Access Compliance Report

Public Rights-of-Way

(Curb Ramps)

Intersection ID: N/A	Main Street: CALDWELL_RD	Cross Street: SUNBURST_LN	Location: SE
ADA ID: 22E9091EF3F0	Ramp Type: PerpDiag	Initial Pass/Fail: Fail	Overall Compliance: No
Severity Score: 21.25			
Codes/Mitigation Info/Possible Solution		Field Measurements/Component Compliance

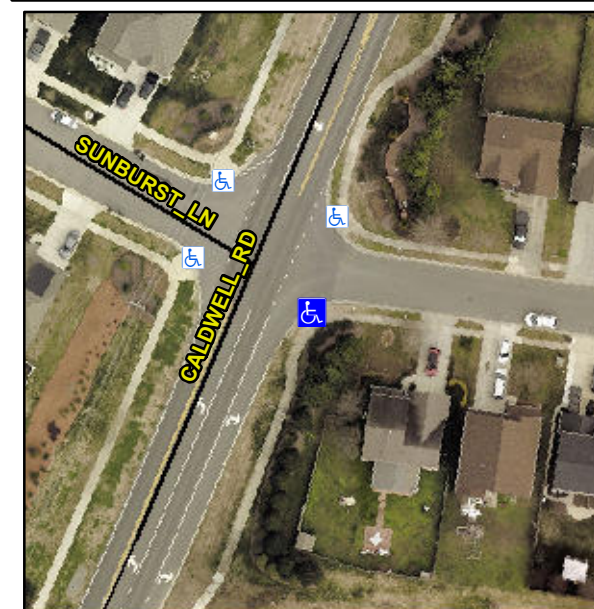
Compliance	Description	Data	Compliance	Description	Data
N/A	Ramp Length (in)	50.0	Yes	Ramp Slope (%)	8.1
No	Ramp Width (in)	42.0	No	Ramp XSlope (%)	6.0
N/A	Flare Type LT	N/A	N/A	Flare Type RT	N/A
N/A	Flare Slope LT (%)	N/A	N/A	Flare Slope RT (%)	N/A
N/A	Flare Traversable LT?	N/A	N/A	Flare Traversable RT?	N/A
N/A	Landing Length (in)	N/A	N/A	DWS Provided?	N/A
N/A	Landing Width (in)	N/A	N/A	DWS Contrast?	N/A
N/A	Landing Slope (%)	N/A	N/A	DWS Length (in)	N/A
N/A	Landing X Slope (%)	N/A	N/A	DWS Full Width?	N/A
N/A	Landing Curb? (Y/N)	N/A	N/A	DWS Offset (in)	N/A
N/A	Shared Landing?	N/A			
N/A	Gutter Ponding?	N/A	N/A	Gutter Slope (%)	N/A
N/A	Gutter Lip Ht (in)	N/A	N/A	Gutter X Slope (%)	N/A
N/A	Painted X Walk1?	No	N/A	Painted X Walk2?	No
	X Walk 1 Direction	To NE		X Walk 2 Direction	To NW
N/A	X Walk 1 Width (in)	N/A	N/A	X Walk 2 Width (in)	N/A
	X Walk 1 Slope (%)	4.0		X Walk 2 Slope (%)	6.0
	X Walk 1 X Slope (%)	6.6		X Walk 2 X Slope (%)	0.6

N/A	Ramp inside XWalk1?	N/A	N/A	Ramp inside XWalk2?	N/A
	Road Slope (%)	2.5	N/A	Clear Space?	N/A
	Road X Slope (%)	6.2	N/A	Clear Space to XWalk (in)	N/A
N/A	Any Obstructions?	N/A	N/A	Storm Grate/Utility Hazard?	N/A
	Obstruction Type			Storm Grate/Utility Type	
		N/A			N/A
			Yes	Surface Condition? (G/P)	Good

Remove & Replace Curb Ramp With Two New Directional Ramps or Equivalent.

R304.5.1, R304.5.3
